**Project: IEEE P802.15 Working Group for Wireless Personal Area Networks (WPANs)**

**Submission Title:** [Proposal for MR-FSK 4-Level Preamble and SFD Values]

**Re:** [TG4g Letter Ballot 59 Comment Resolution]

**Abstract:** [This proposal provides the explicit specifications of the preamble and SFD values for filtered 4-FSK.]

- 6.3a.1.1 Preamble field (page 38)

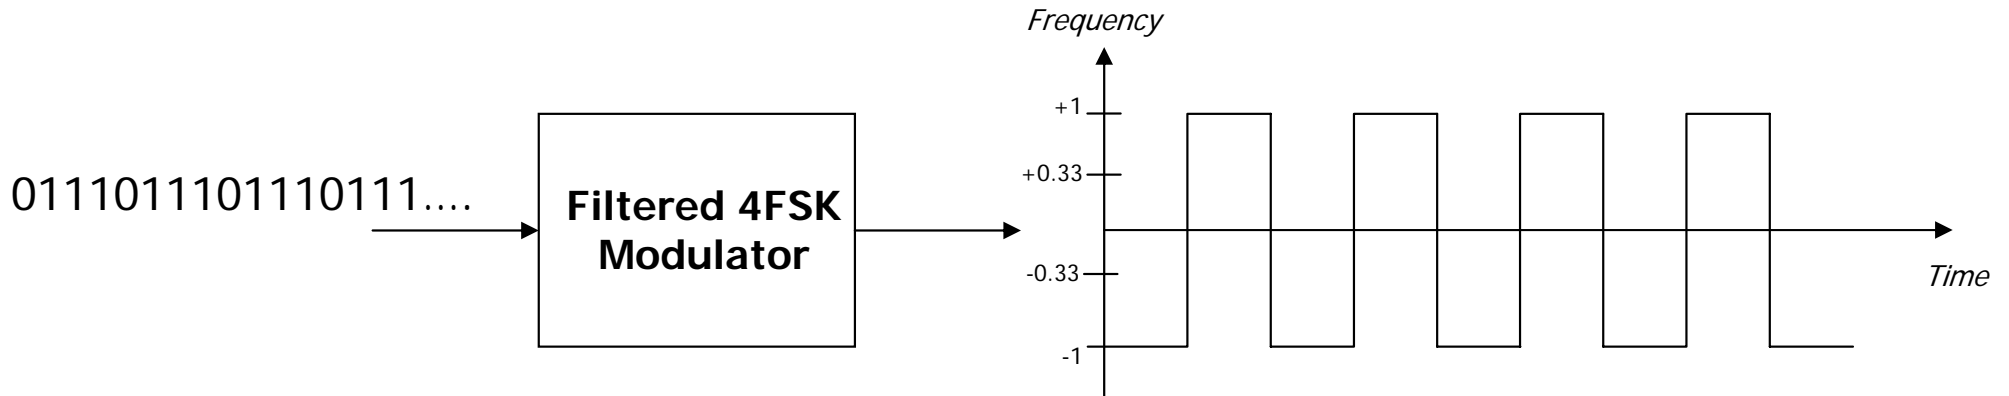
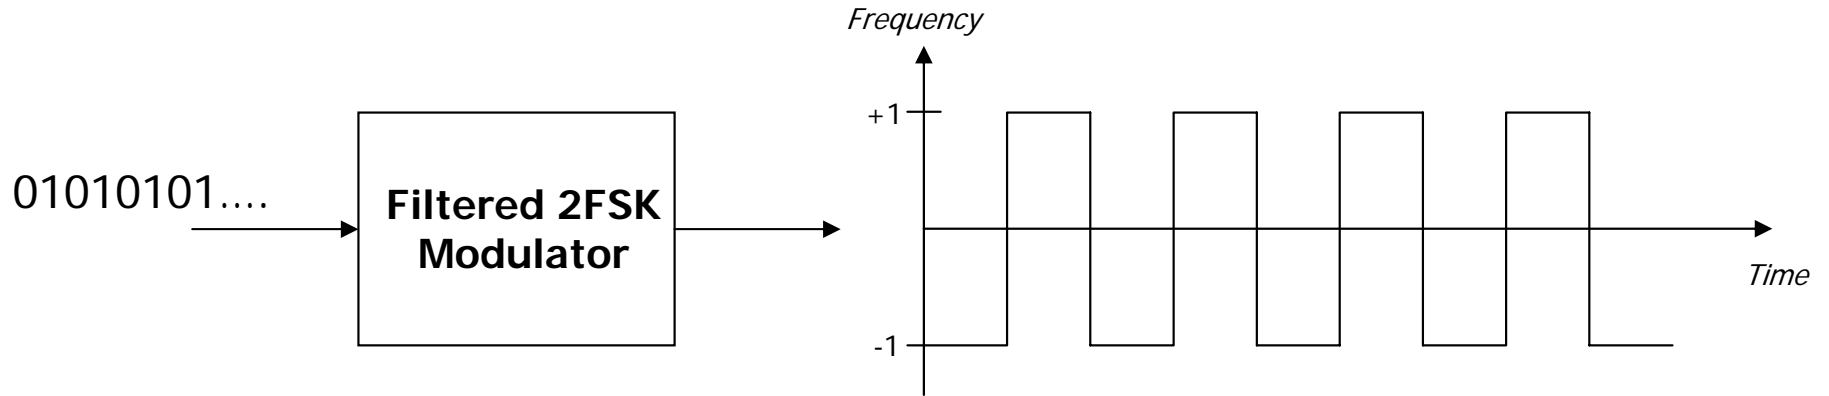
*Proposed Change:*

From

“The Preamble field shall contain phyFSKPreambleRepetitions multiples of the 8-bit sequence “01010101.””

to

“The Preamble field shall contain phyFSKPreambleRepetitions multiples of the 8-bit sequence “01010101” for filtered 2-FSK.

The Preamble field shall contain phyFSKPreambleRepetitions multiples of the 16-bit sequence “0111011101110111” for filtered 4-FSK.”

- This 4-level preamble sequence is functionally the same as the 2-level preamble sequence, and both preamble sequences have eight symbols.
